Met One Instruments would like to renew the following exempt distribution license:

- License number 36-23875-01E
- Expiration date: November 30, 2010

Changes

The source material has not changed however the manufacturer's name changed as follows:

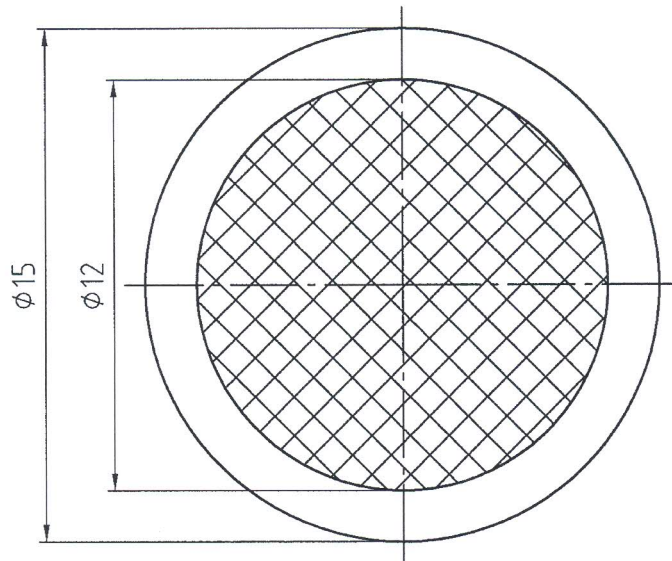
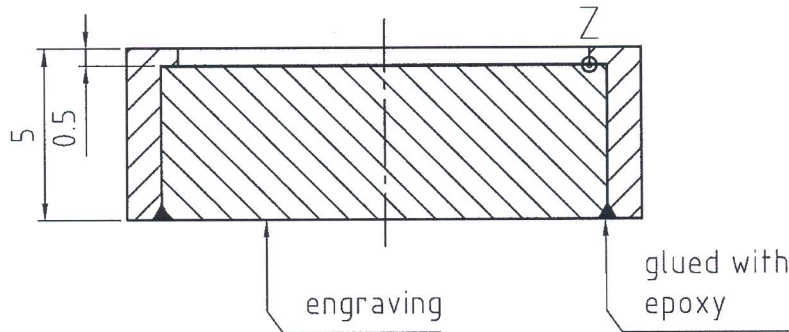
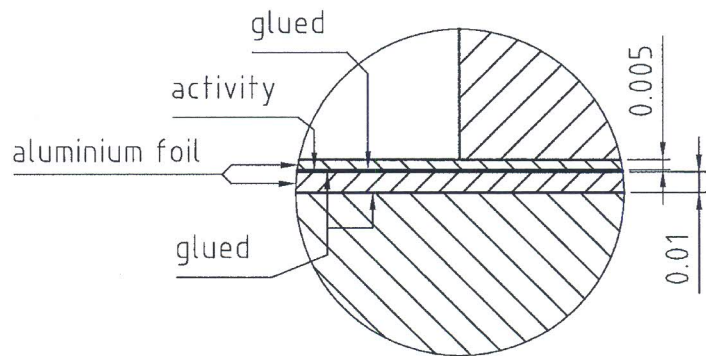
- Manufacturer's name was: AEA Technology QSA, Inc.
- Manufacturer's name is: Eckert & Ziegler Nuclitec GmbH

1. Letter from supplier describing the name change. This correspondence also states:
 "Today the product itself is manufactured at Eckert & Ziegler Nuclitec GmbH in Braunschweig, Germany by same people in the same laboratory as 30 years ago."
2. Updated source drawing including manufacturer's name.
